**Assessment of Pipeline Integrity  
of Kinder-Morgan Conversion  
Of the Rancho Pipeline**

**City of Austin Texas**

**June, 2004**

Figure 2. ILI Data Review.

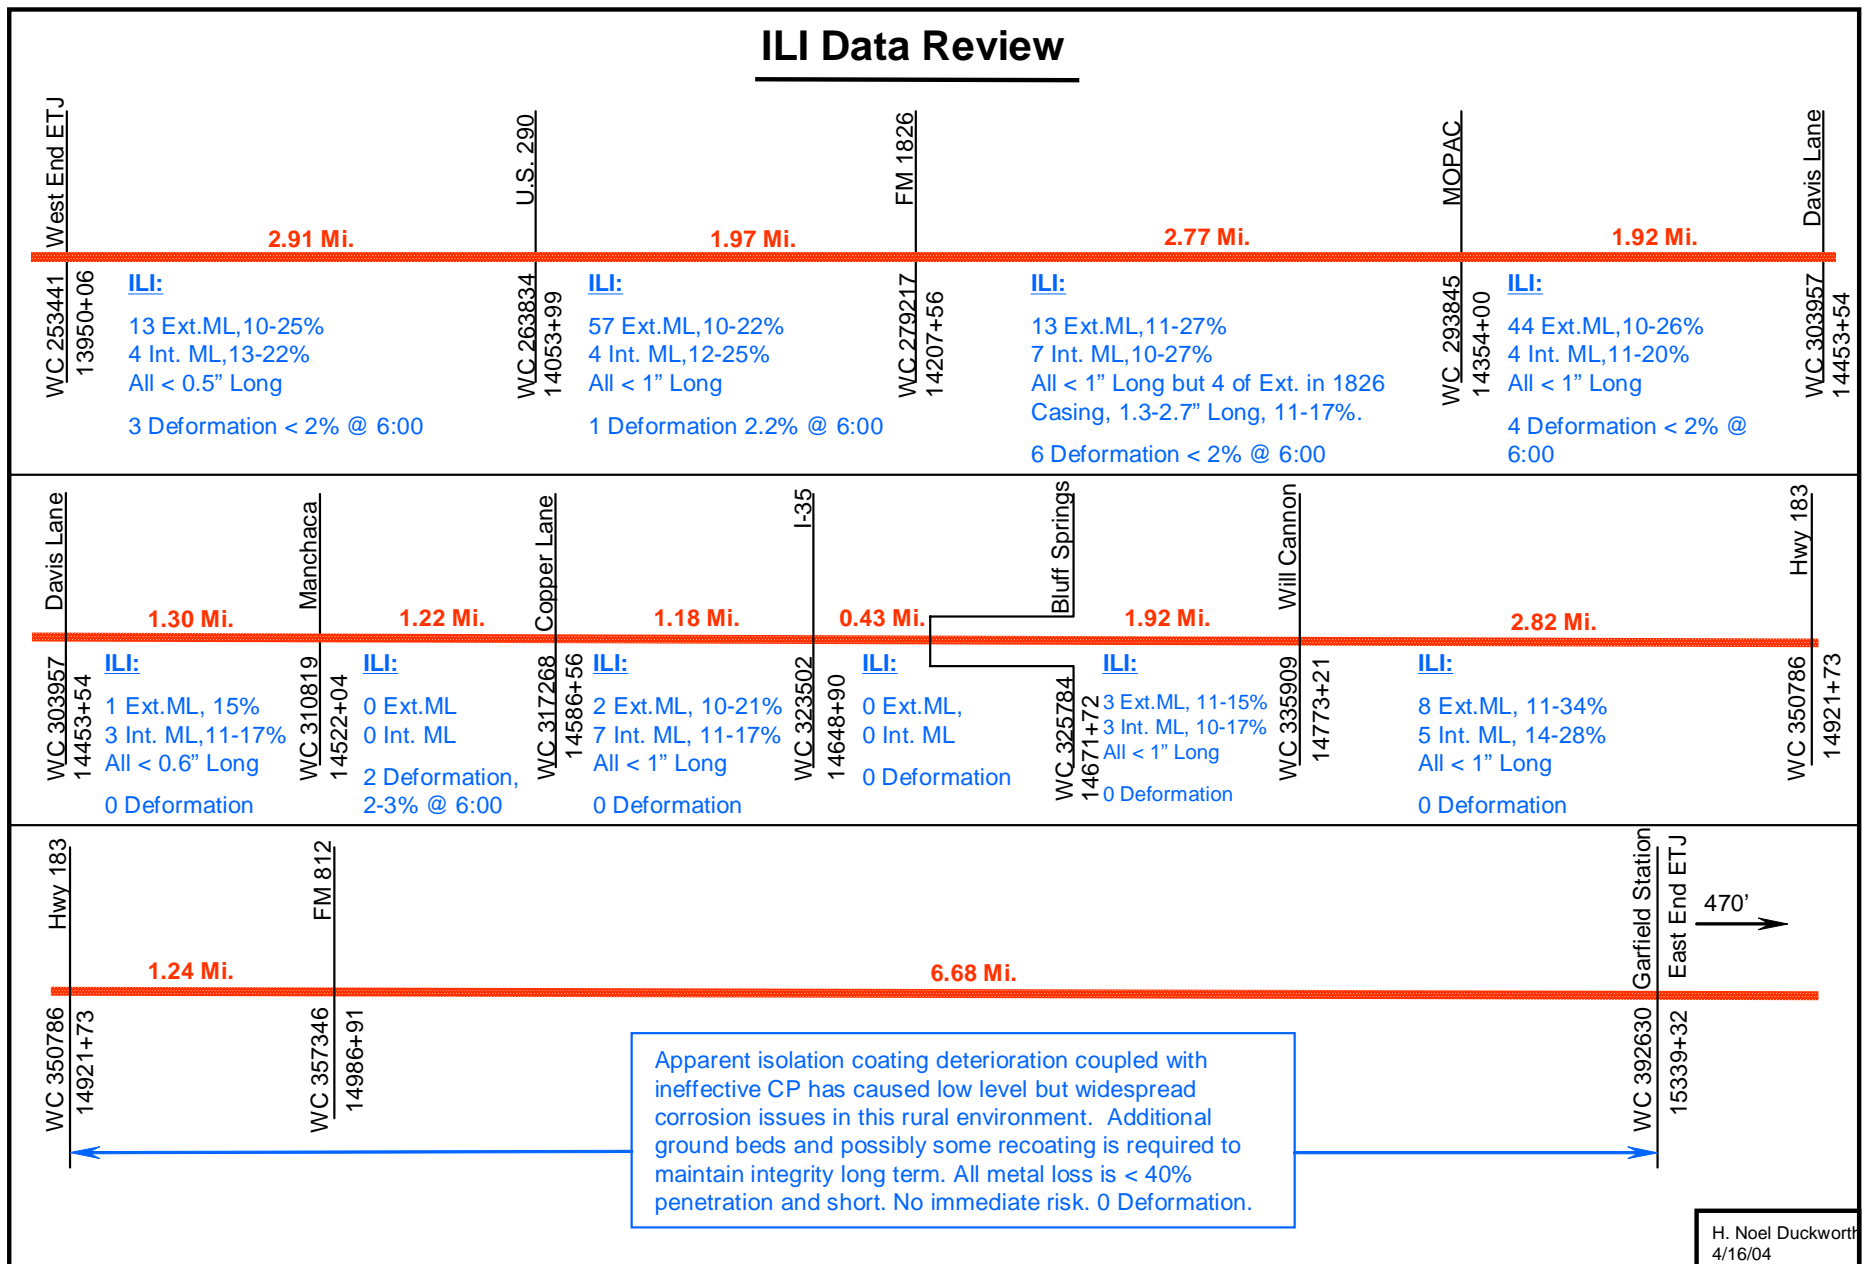
All of the 2003 ILI data was evaluated from both the High Resolution Magnetic Flux (HRMFL) as provided by GE-PII and the Deformation survey data provided by Enduro and the data was found to be of high quality and therefore should identify the anomalies detectable with the tools employed (see Table 4) in the pipeline. The results of this evaluation can be seen graphically in Figure 2.

Figure 2 shows that most of the corrosion from the Western boundary of the ETJ to Highway 183 East of I-35 is very isolated, shallow, and short along the longitudinal axis. It is obvious that these locations are not injurious in their present state and they appear to be under control from a cathodic protection point of view. Between Highway 183 and the Eastern ETJ boundary, there is a much higher density of external coating problems with apparent ineffective cathodic protection which has, over the course of many years, caused low level but widespread corrosion issues in this mostly farmland environment.

**Figure 6. Calculated Failure Pressures of Anomalies Removed From 24" x 0.312" X52 Rancho Pipe**

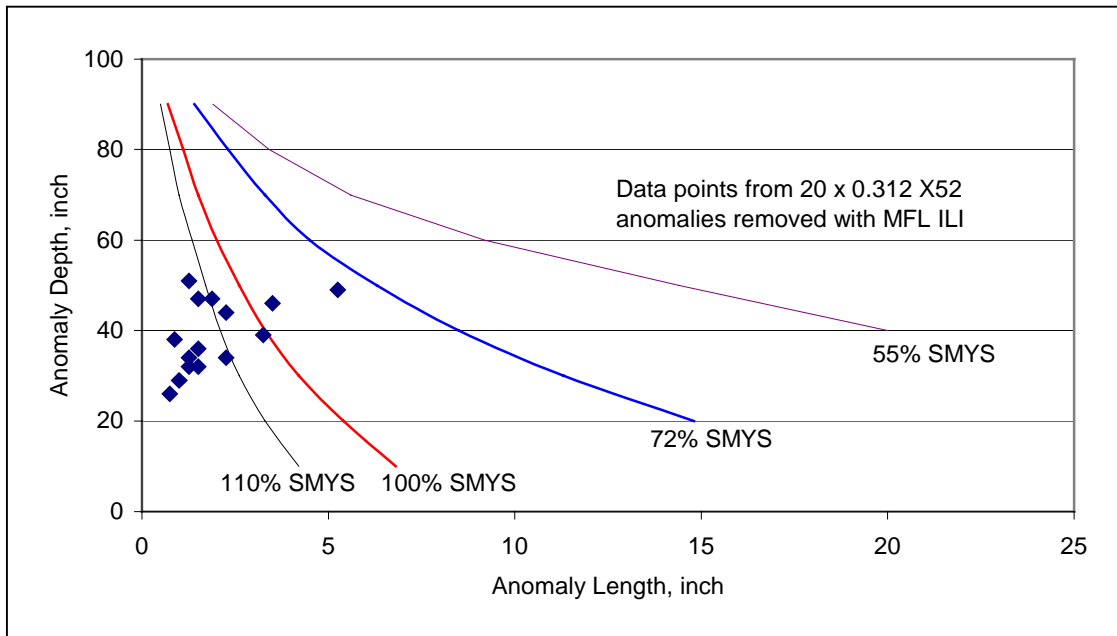
Kinder-Morgan has removed all pipe containing metal loss defects that exceed 40% wall thickness penetration regardless of length. As shown in Figure 6, all of the defects removed are significantly below and to the left of the 55% of SMYS curve. Thus, this action, a requirement of the K-M Company operating procedures, exceeds those mitigation actions required by Federal and State codes and further, it exceeds common Industry Standards.

Figure 6 presents the lengths and depths of the anomalies removed from the Rancho Pipeline. These are compared to calculated curves of failure stress levels for various length rectangular flaws in the Rancho pipe. All but two of the data points have calculated failure pressures above 100% SMYS. The two data points below 100% SMYS have calculated failure pressures of 77 and 93 % SMYS. These two would have failed in the planned hydrotest. The three data points between 100 and 110% SMYS may also have failed in the hydrotest depending on the elevation of the pipe at their locations. The remaining 10 data points have failure pressures that are too high to reach in a hydrotest illustrating the benefit of using ILI in place of hydrotesting for metal loss anomaly removal. Thus, while there is a length accuracy issue with the HRMFL data, the HRMFL is still capable of detecting anomalies that are much smaller than could be detected with a pressure test.

**Figure 7. Critical Flaw Depths and Lengths in 24 x 0.312 inch X52 Pipe**

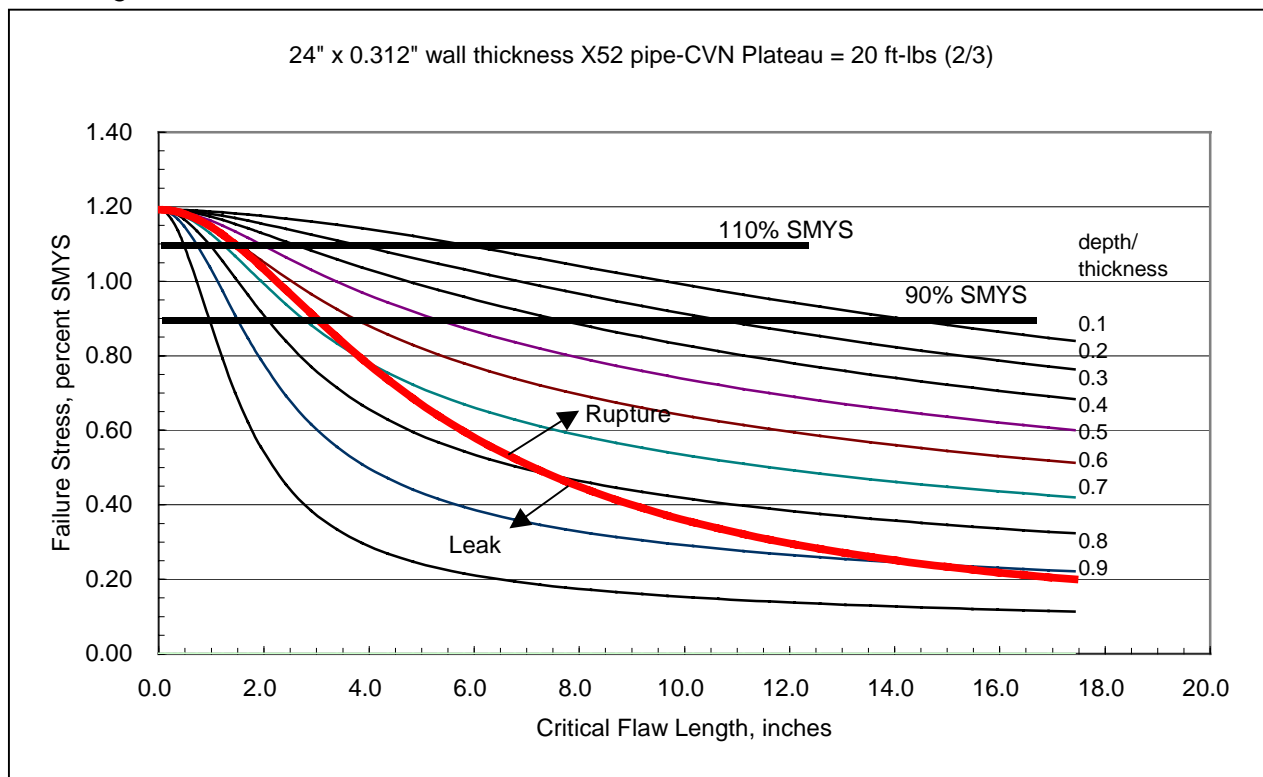
To assess the significance of the test stress level a calculated curve of flaw depths and lengths is presented in Figure 7. Figure 7 shows a calculated<sup>15</sup> plot of flaw sizes that are on the verge of failure at the stress levels shown for the 24 by 0.312 inch wall thickness X52 pipe with a pipe toughness (Charpy V-notch impact plateau energy) of 20 ft-lbs based on a 2/3 width specimen. (A similar plot exists for the 24 x 0.344 inch wall thickness X52 pipe except that the flaws are slightly larger at the same stress level.) A series of curves are shown along with a heavier curve that crosses the other curves. The series of curves are labeled with d/t values from 0.1 to 0.9, which indicates the depth, d of the flaw to the thickness, t of the pipe. Horizontally, the effect of total flaw length is shown, indicating that the longer a flaw, the lower the failure stress. Similarly the deeper a flaw, the lower the failure stress. The flaws represented by the curve are flaws of uniform depth or rectangular flaws. (This provides a conservative estimate of the failure stress as most flaws are parabolic and will have a higher failure stress.)

Figure 7 indicates that at a 90% SMYS minimum stress level proposed for the pressure test, flaws that range from 1.2 inches long by 90% deep to 16.7 inches long by 10% deep would be on the verge of failure in the test. In the 24 x 0.344 inch X52 pipe, the stress levels are even lower, i.e., the minimum is 81.6% SMYS and the maximum is 92.6% SMYS in Kinder-Morgan's proposed hydrostatic pressure test plan. At a stress of 81.6% SMYS the surviving flaw sizes in

Three changes that improve the proposed pressure test are to separate the test sections at the location of the wall thickness change from 0.312 inches to 0.344 inches. Then the 0.312 inch wall thickness and 0.344 inch wall thickness sections can be each be tested to high pressure levels, typically 90 to 100% SMYS or higher. Option 1 only tests the 0.344 inch wall thickness pipe to 81.6% SMYS. This is illustrated in Figure 4, which is a revision of the Option 1 test plan.
